Subject: Site Location of Development Law and Natural Resources Protection Act Applications on behalf of Calais LNG Project Company, LLC & Calais LNG Pipeline Company, LLC, Calais Response to MEDEP Comment letter dated March 30, 2010

This letter is to submit additional information and clarification to address the comments provided to you by David Waddell in a Technical Review Memorandum dated March 29, 2010, which specifically reference Sections 12 and 14 of the Site Location of Development (SLOD) Permit application submitted to you in January, 2010. The numbered responses correspond to the numbered comments in David's letter.

**FIGURE 18R**

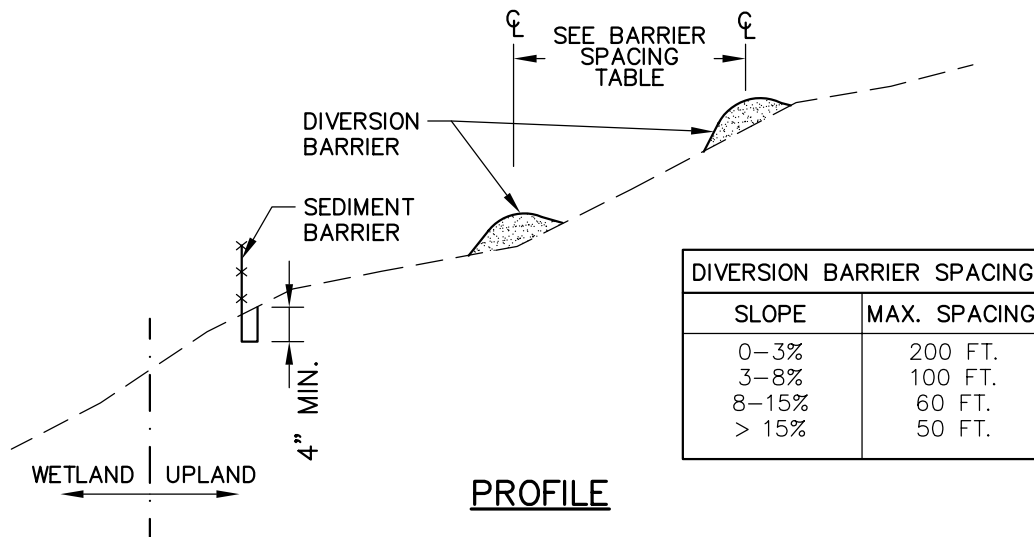
2. Attached please find Figures 17R and 18R, dated April 2010. These correct and replace the E&SCR Plan Figures 17 and 18 originally submitted. The siltation fence fabric trench is now shown on the uphill side of the fence.

**FIGURE 27**

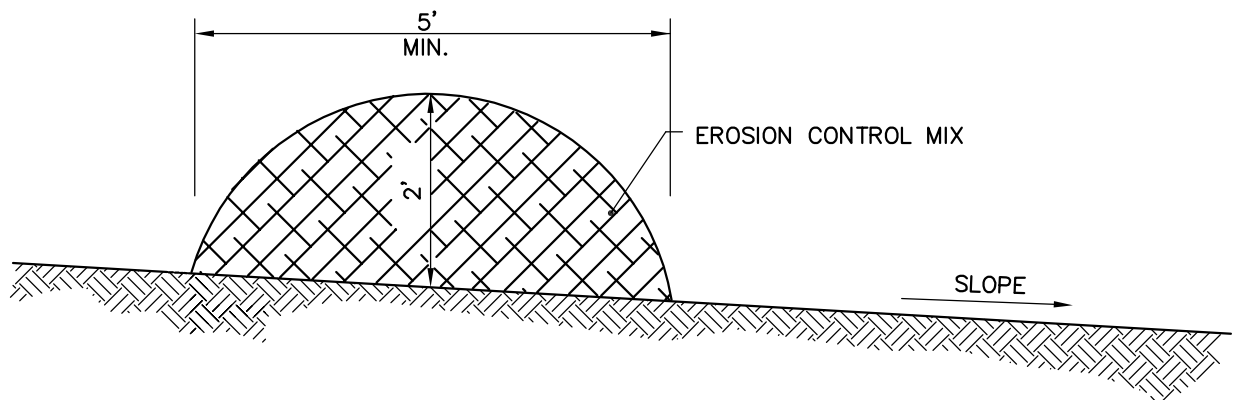
3. Attached please find Figure 27, an Erosion Control Mix Berm detail, which is to be added to the E&SCR Plan. This detail makes clear that stump grindings are acceptable for installation of Erosion Control Mix Berms, but that wood chips are not.

FIGURE 23R

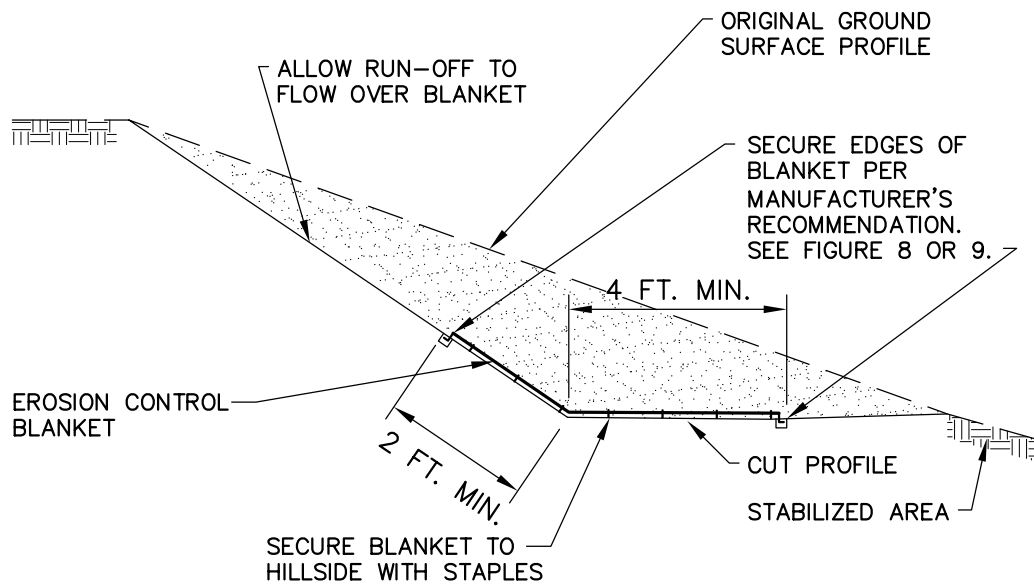
4. Attached please find Figures 22R and 23R dated April 2010. These clarify and replace the E&SCR Plan Figures 22 and 23 originally submitted. They are included in the E&SCR Plan to inform the Contractor of the need and method for the installation of erosion control blanket at the toe of constructed slopes when site topography may result in areas of concentrated flow that need additional erosion control measures until vegetation is established.

**SLOD FIGURE  
12-5A REV**

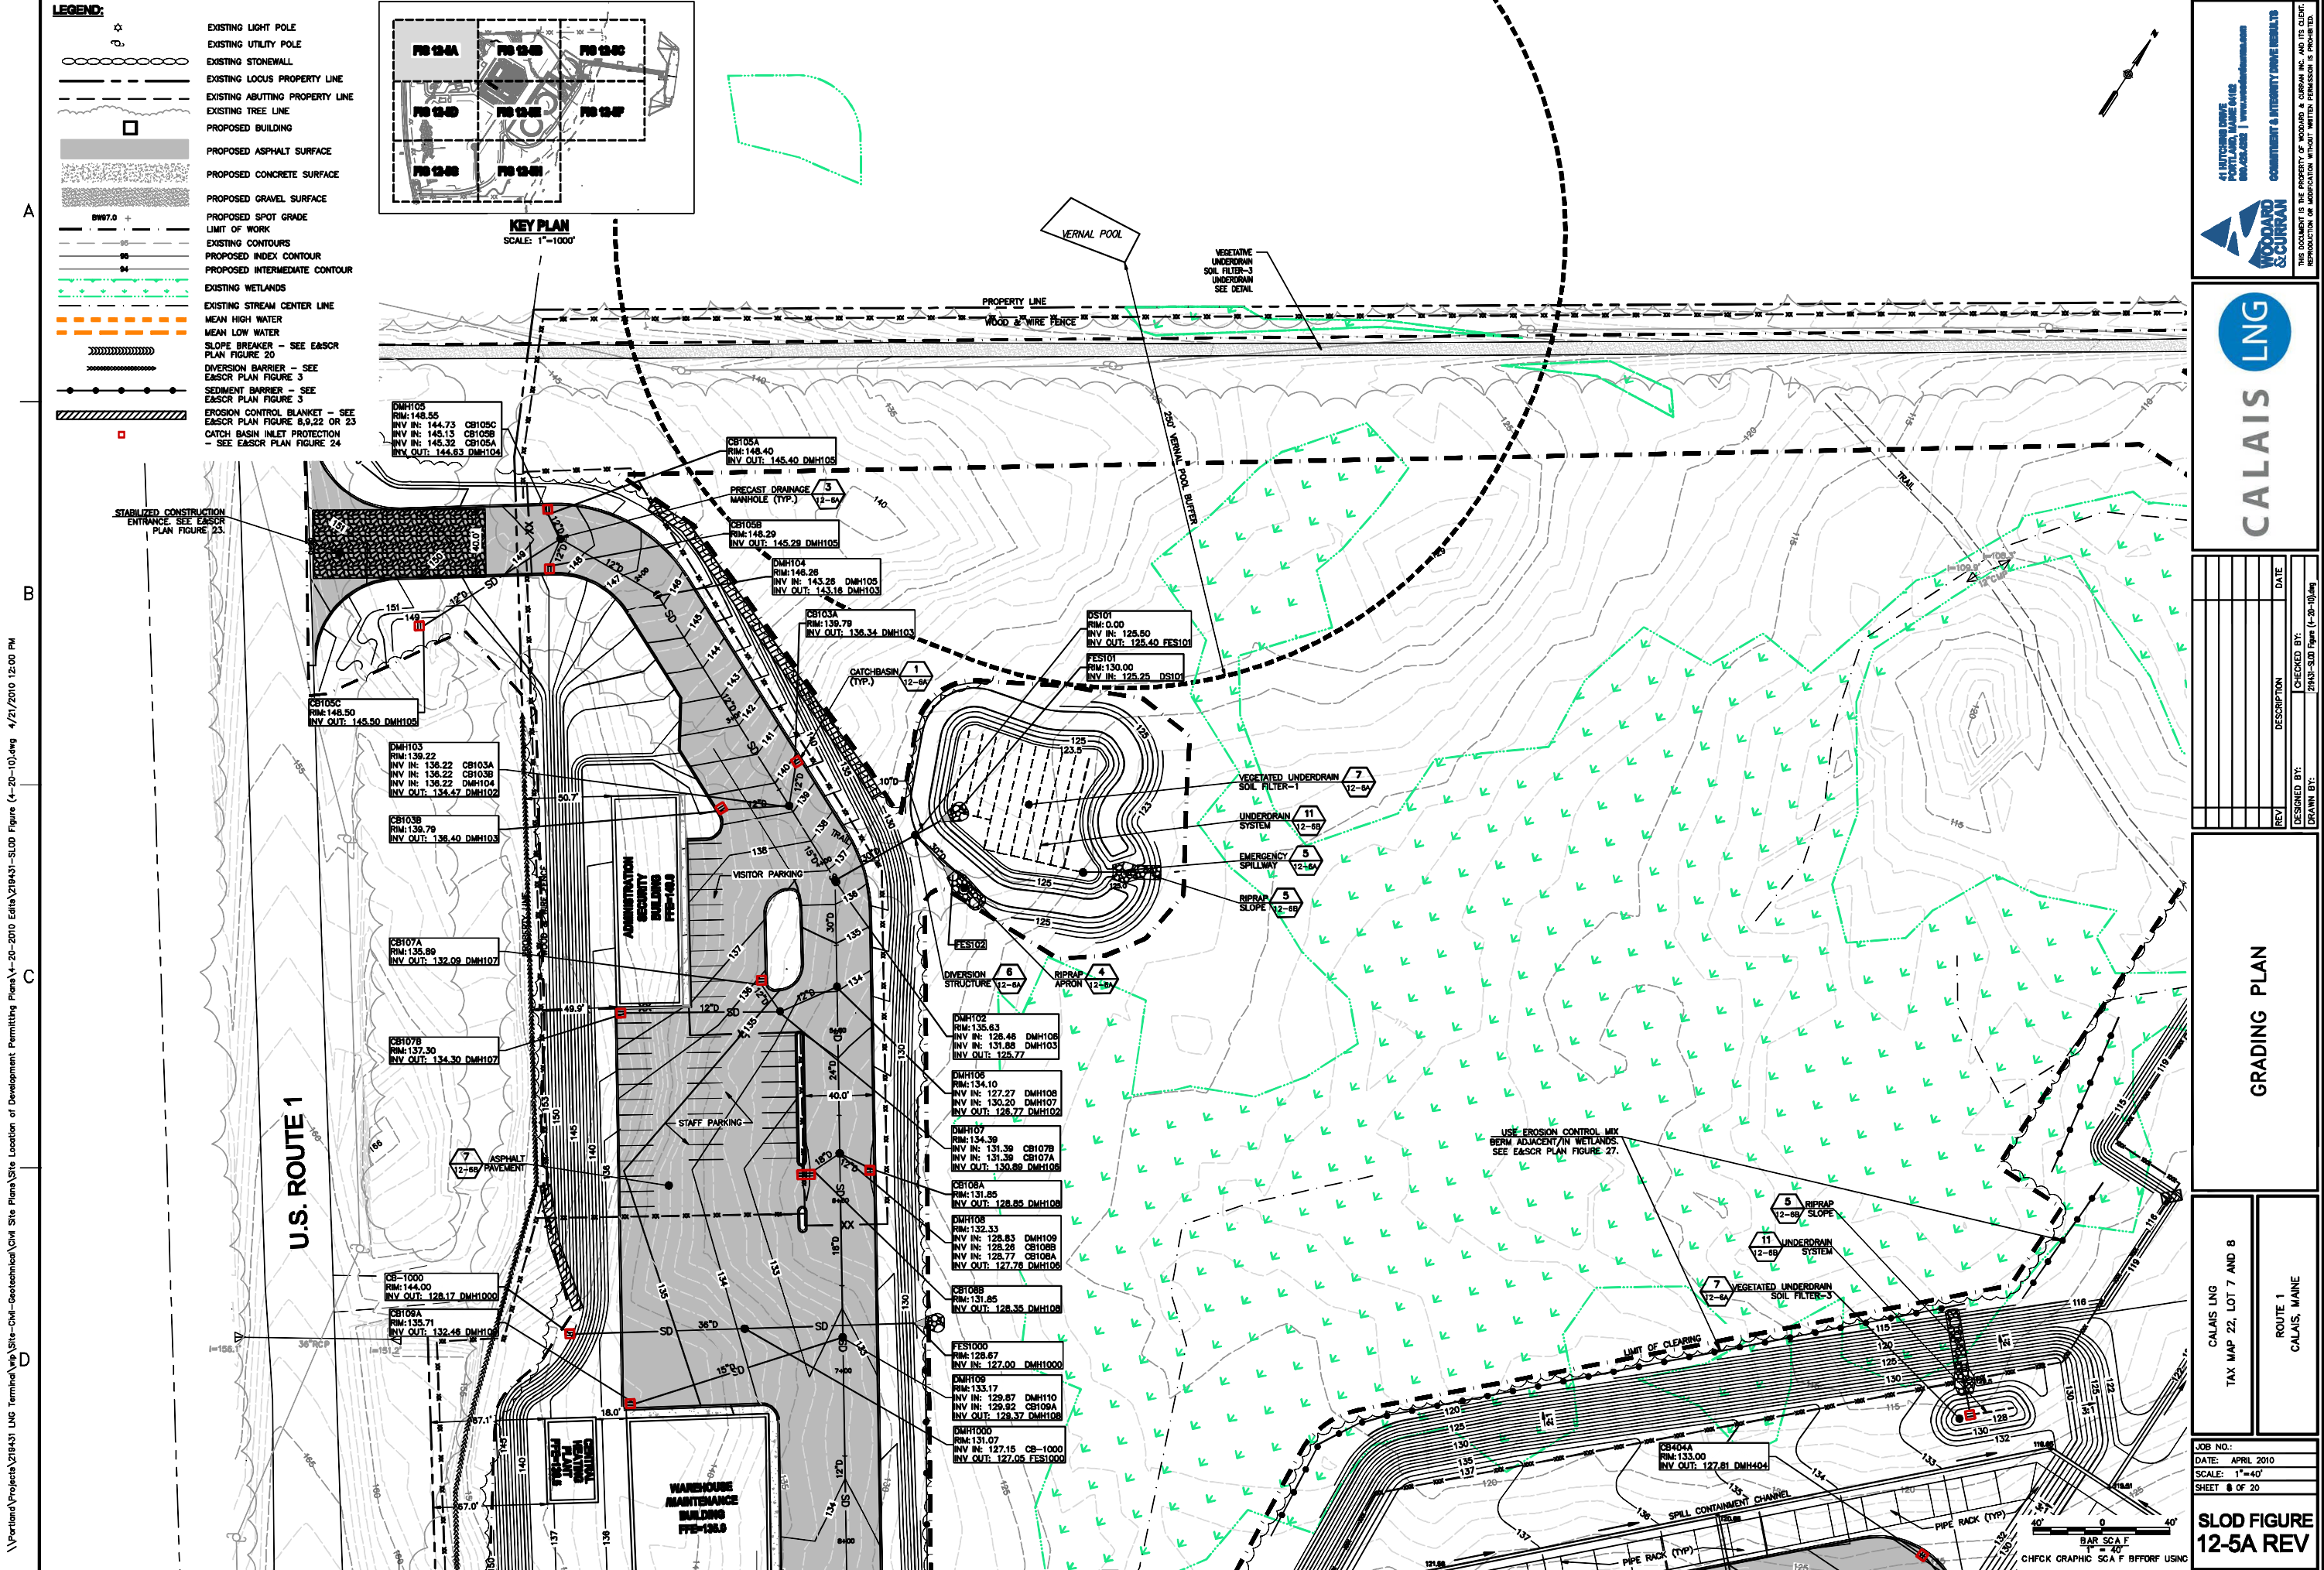
7. The erosion and sediment controls shown on SLOD Figure 12-6B are for permanent measures at the Terminal Site; temporary erosion and sediment control measures that will be employed during construction of the Terminal Site are shown on the details in the E&SCR Plan. Attached

please find detailed Grading Plans of the Terminal Site (SLOD Figures 12-5A REV through 12-5H REV), which have been revised to show critical locations for installation of temporary erosion and sediment control measures.

**SLOD FIGURE 12-5H REV**

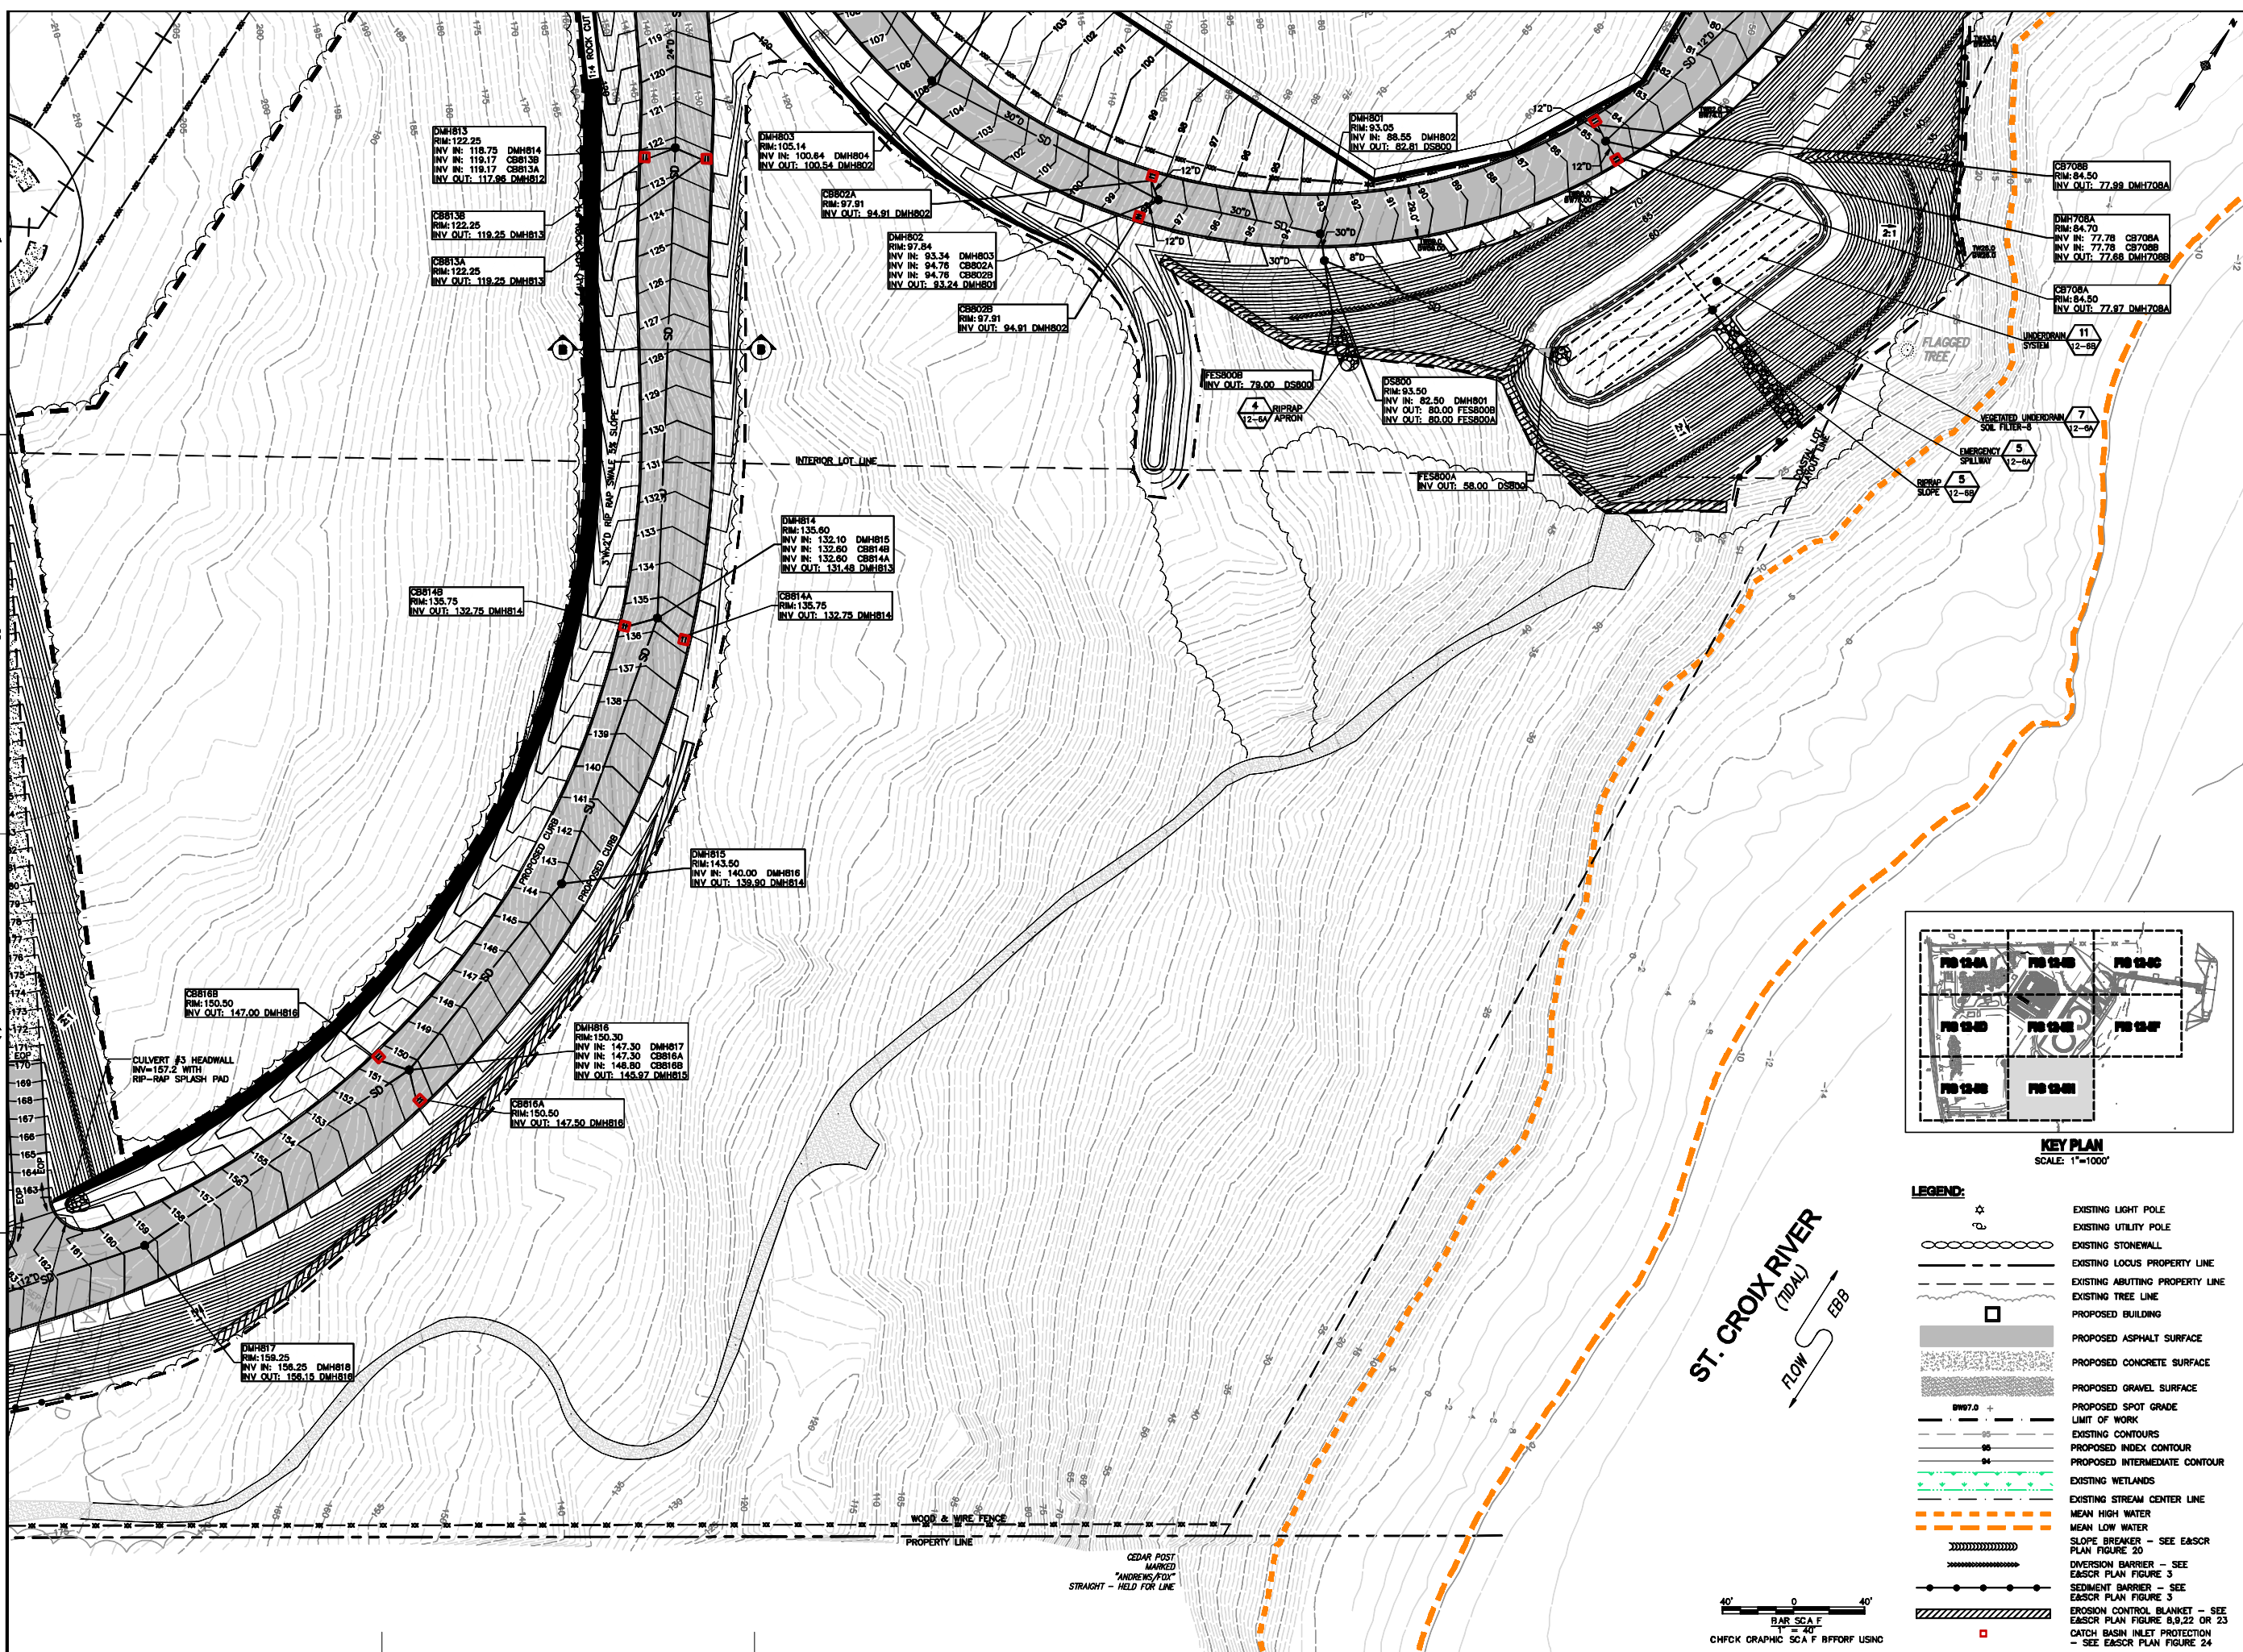
14. Cross-section A on SLOD Figure 12-6C is through the entrance road and buffer shown in plan view on Figure 12-5G. The cross-section is correct. The table below matches cross-sections to their plan view locations for ease of reference.
